ABBREVIATED PLAT AGENDA ASSEMBLY CHAMBERS 350 EAST DAHLIA AVENUE, PALMER

REGULAR MEETING **8:30 A.M.** **May 21, 2025**

ABBREVIATED PLAT: CROCKER CREEK VISTA PHASE 1

ABBREVIATED PLAT: FONTANA DELLE VOLPI
LEGAL DESCRIPTION: SEC 30, T21N, R04W, SEWARD MERIDIAN AK
PETITIONERS: WILLIAM FONTANA
SURVEYOR/ENGINEER: BULL MOOSE SURVEYING, LLC. / HOLLER ENGINEERING
ACRES: 112.72 ± PARCELS: 2
REVIEWED BY: MATTHEW GODDARD CASE #: 2025-052

CROCKER CREEK VISTA PHASE 1

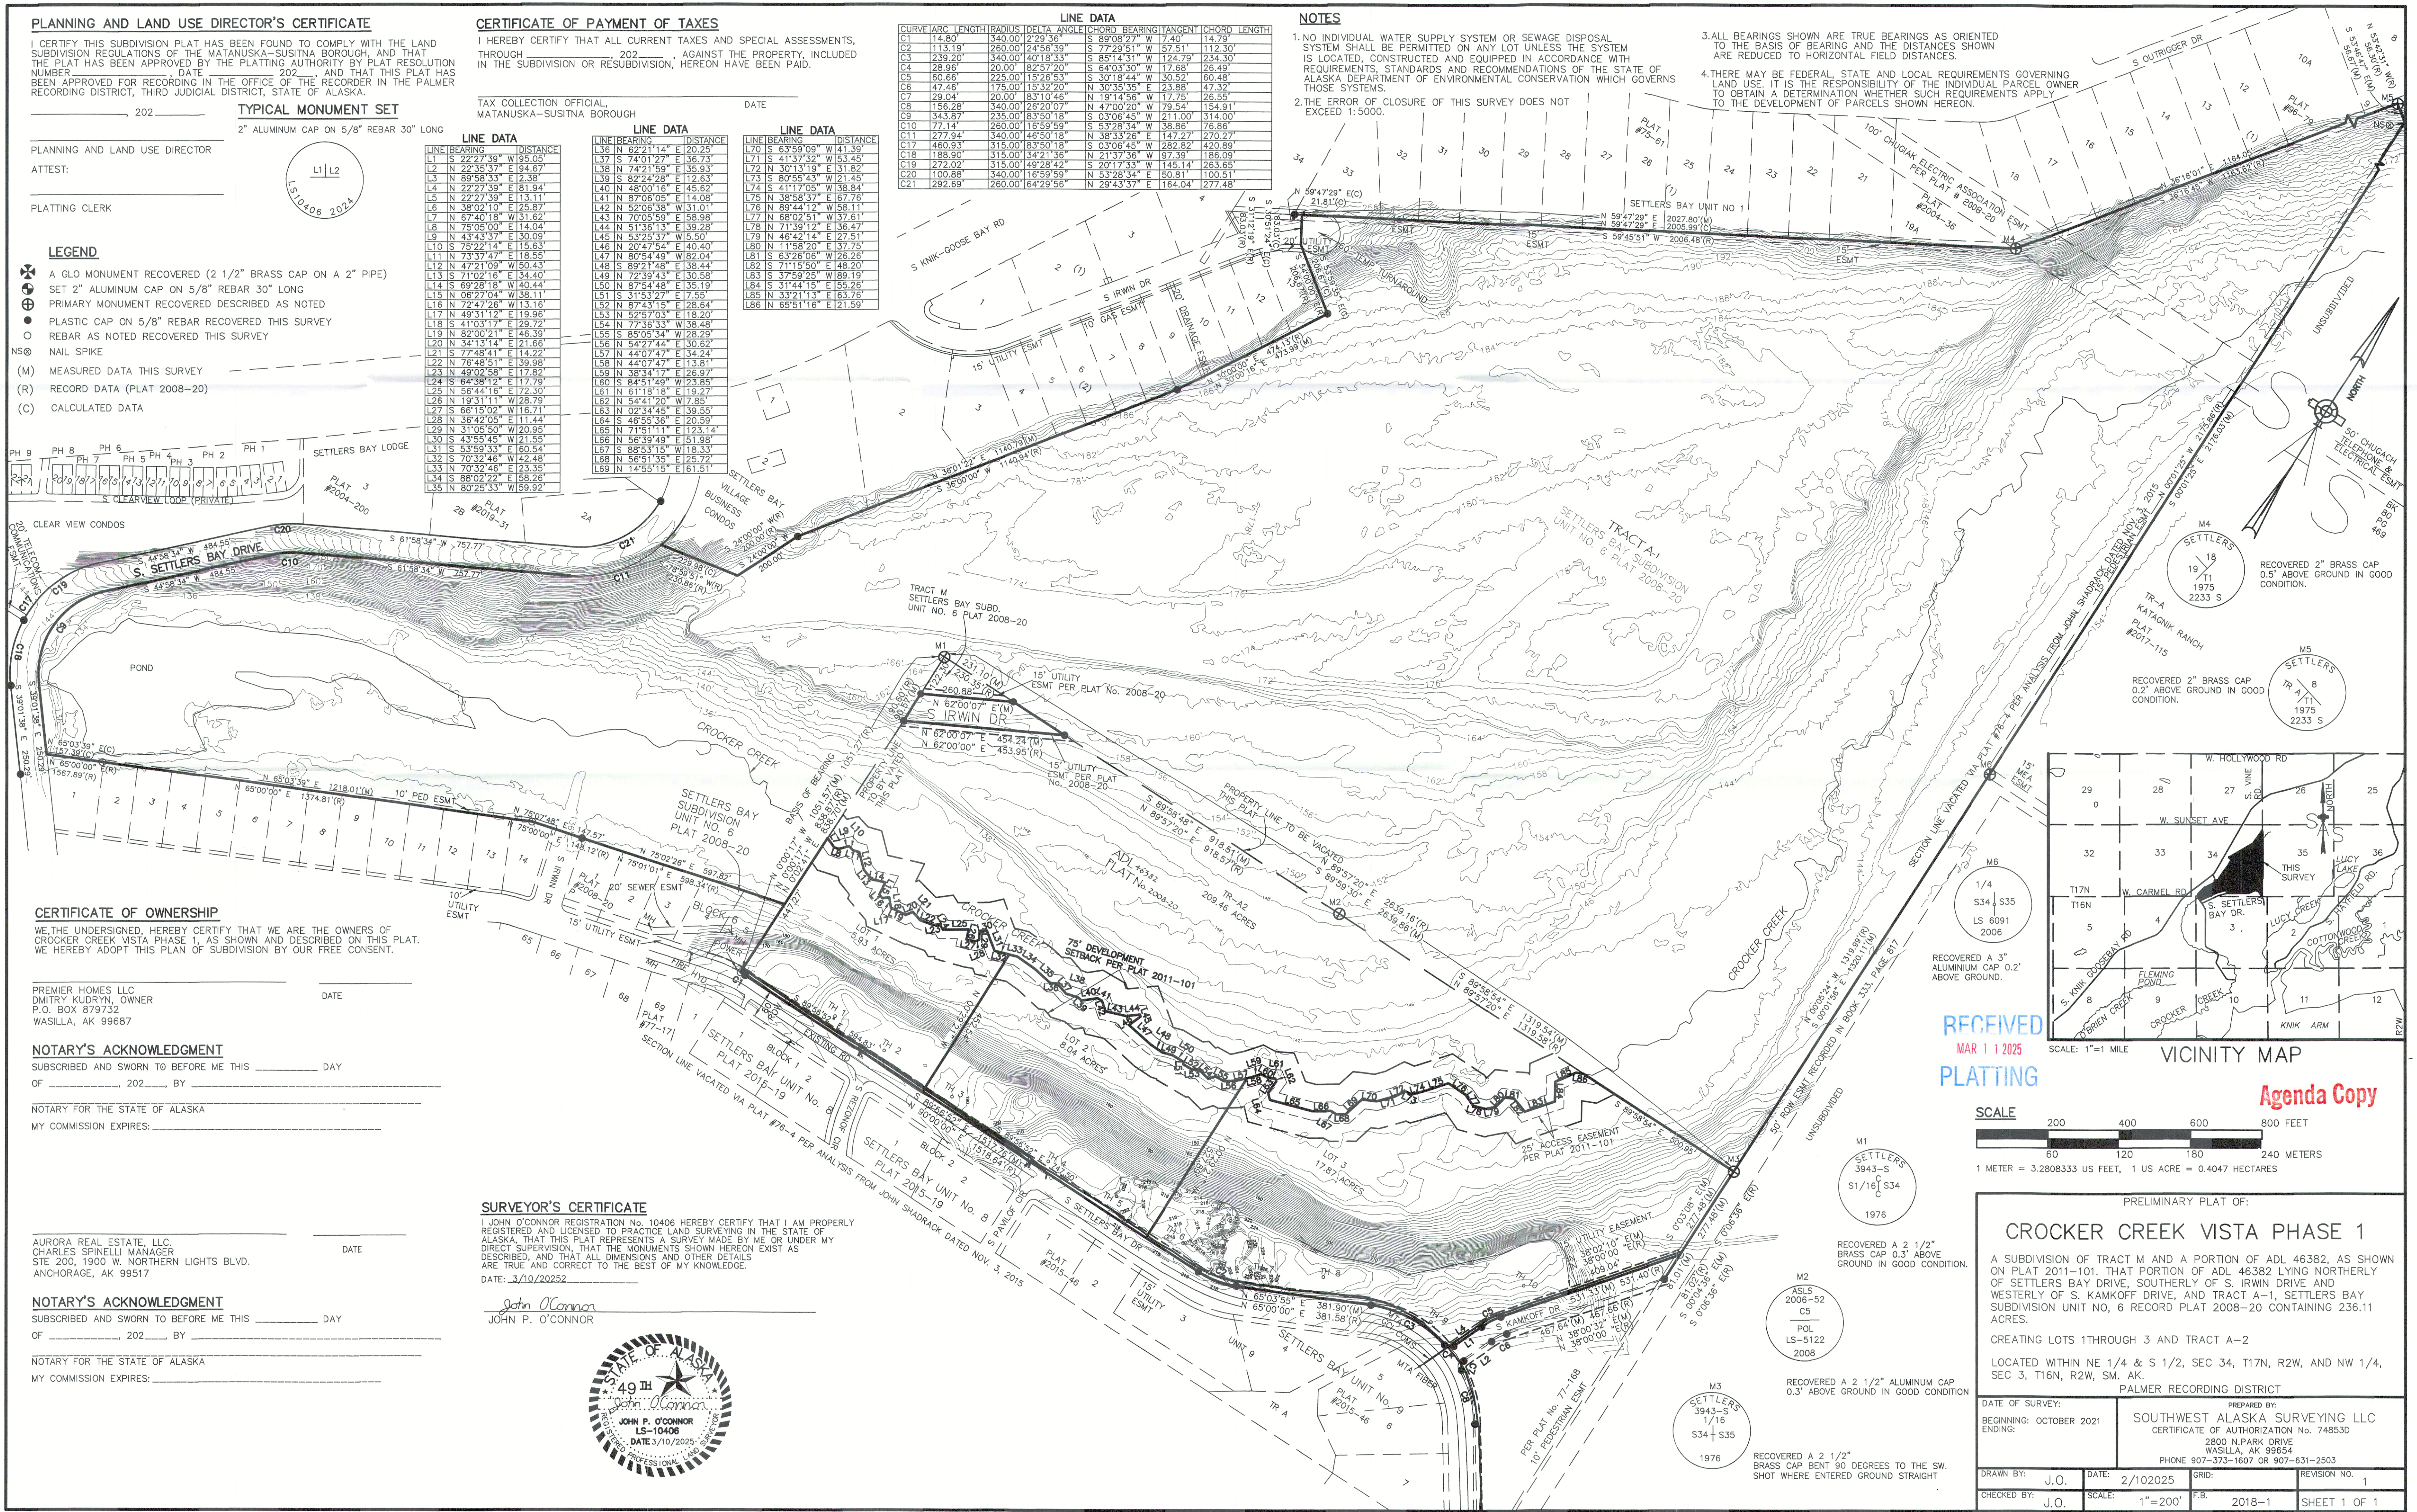
MSB Pre-design & Engineering (Exhibit E) A detail topographic narrative is required for Lot 3 and the remainder Tract per Title 43.20.281 (A)(1)(i)(i). Settlers Bay Drive is a major collector on the OSHP, 2022 SCM B04 is met for average access spacing.

Public: (Exhibit H) Geary Cooper objects and is concerned for the salmon in the creek.

A detail topographic narrative is required for Lot 3 and the remainder Tract per Title 43.20.281 (A)(1)(i)(i). Settlers Bay Drive is a major collector on the OSHP, 2022 SCM B04 is met for average access spacing.

Comments: Much of this area is wetlands.
I would like to know if an environmental/
impact study has been done on this area.
Salmon are just now returning up crocker creek.
About 80 last year. It is also 1 of very few
areas for mouse habitat this close to development.
If no study has been done, then I object to
any further development. Sean

Please make sure to add in 'Resurface of South Settlers Bay' access - this is way out of date, needs to be done for additional traffic - also, need walking/bike trail to alleviate walking on road

Staff notes a Topographic Narrative has been submitted and is at (Exhibit C)

Staff notes AF&G has no objection.

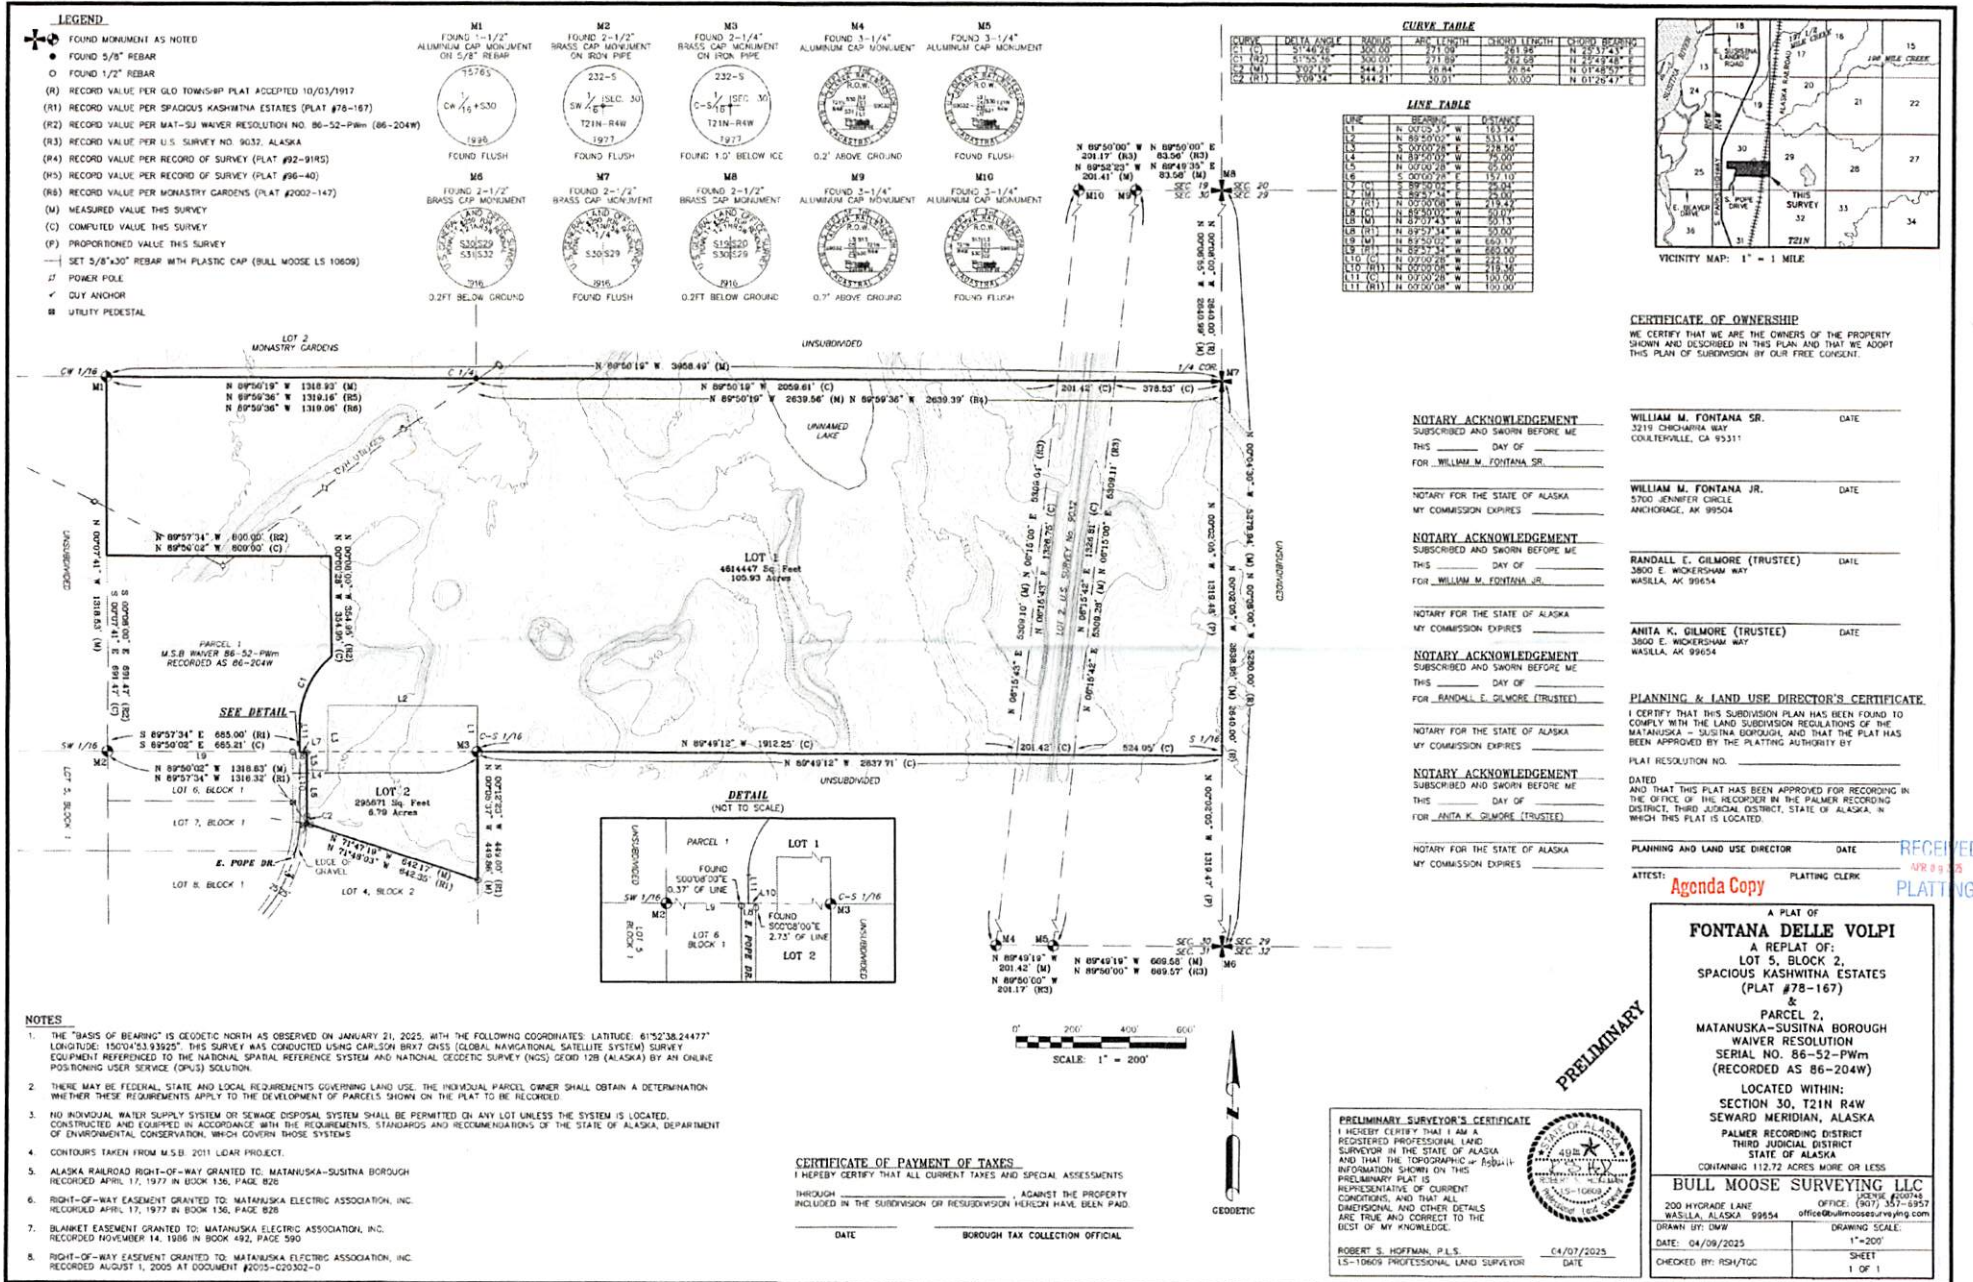
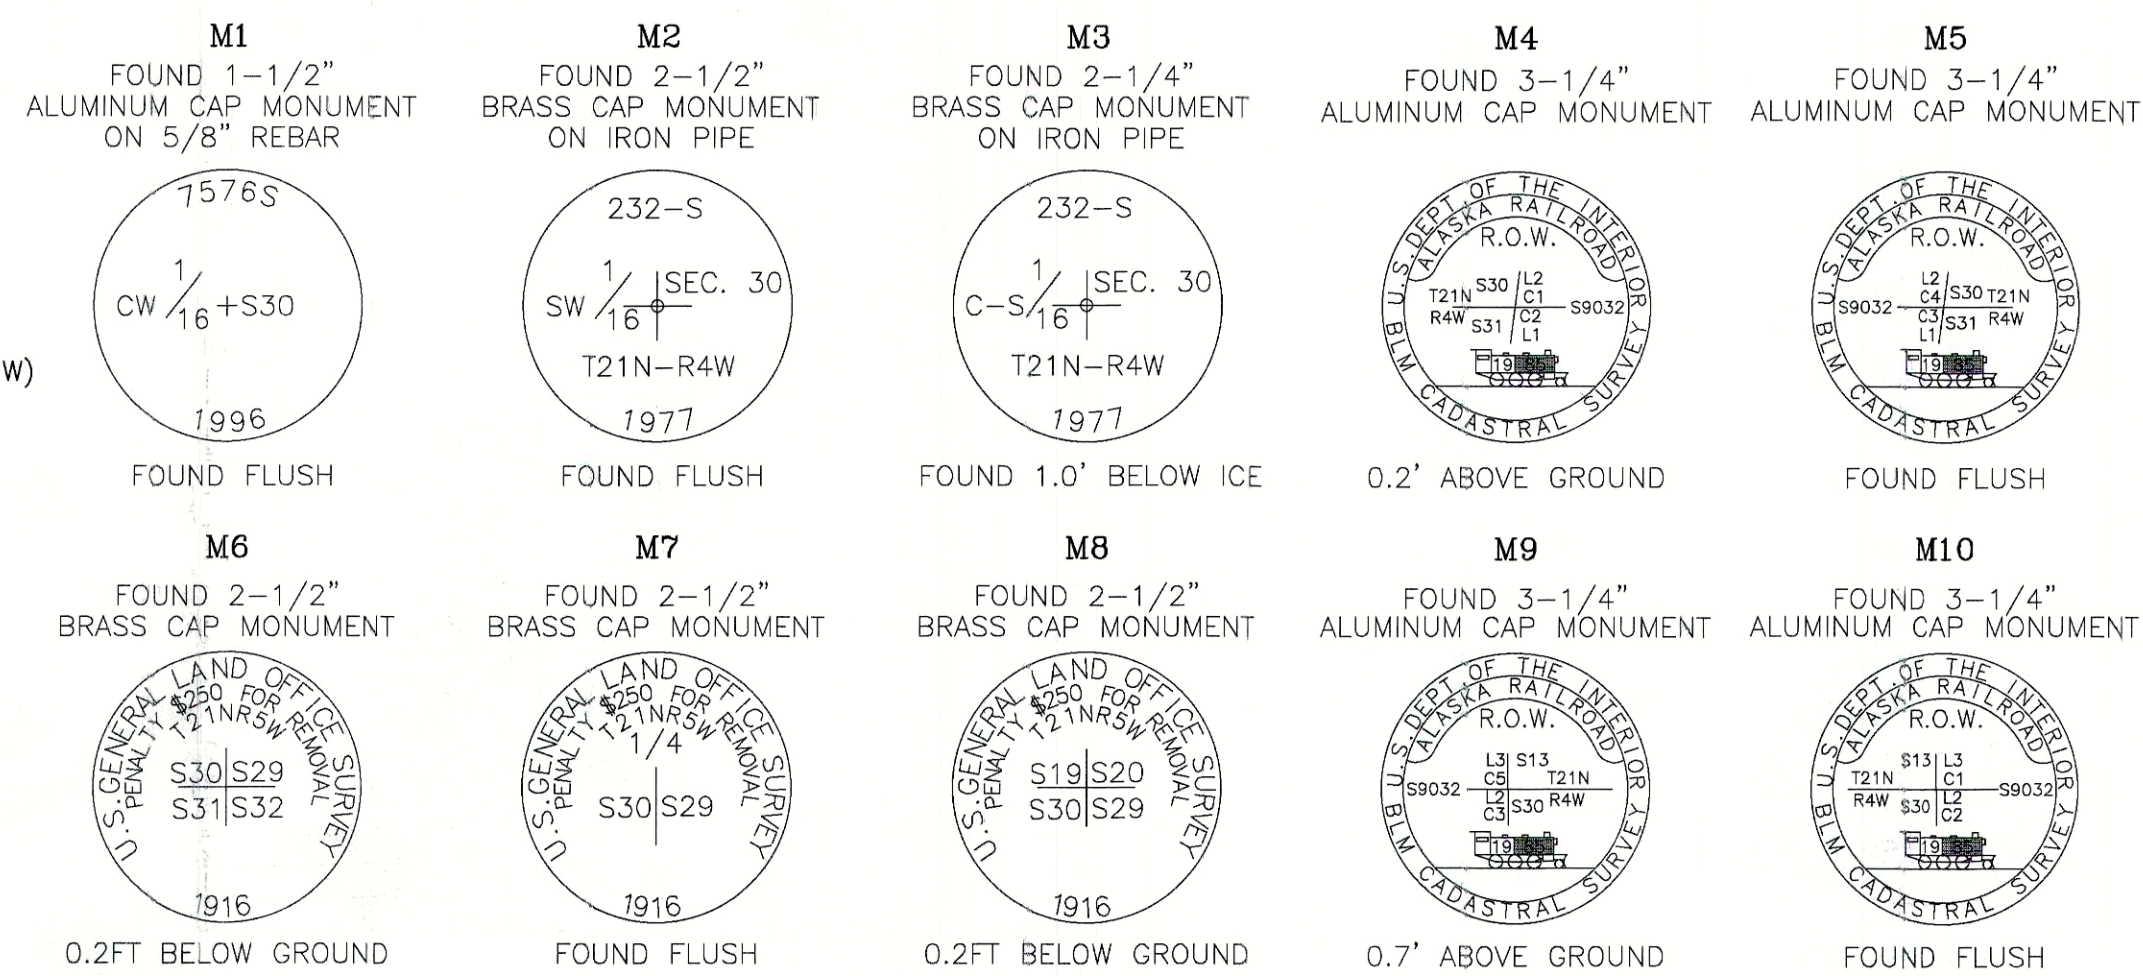
- Note number 5 on the plat is incorrect. The Alaska Railroad did not grant ROW to the MSB in the documents referenced. We request the note be changed accordingly.
Platting staff notes that the plat note references a State of Alaska Patent granted to the Matanuska-Susitna Borough subject to the Alaska Railroad Right-of-way, 100 feet in width on each side of the centerline.

3. The ARRC ROW should be monumented just like other public ROW's. Just as in the examples in the plats in No. 2 above and according to No. 1 Above.
 4. A note be added that calls out ARTA and also the patent that describes the rights of the Alaska Railroad Corporation in lands contained in the U.S. Survey 9032 Lot 2.

3. The ARRC ROW should be monumented just like other public ROW's. Just as in the examples in the plats in No.2 above and according to No.1 above.
 4. A note be added that calls out ARTA and also the patent that describes the rights of the Alaska Railroad Corporation in lands contained in U.S. Survey 9032 Lot 2.

Platting staff notes that the Alaska Railroad exclusive use easement as shown is accurate.
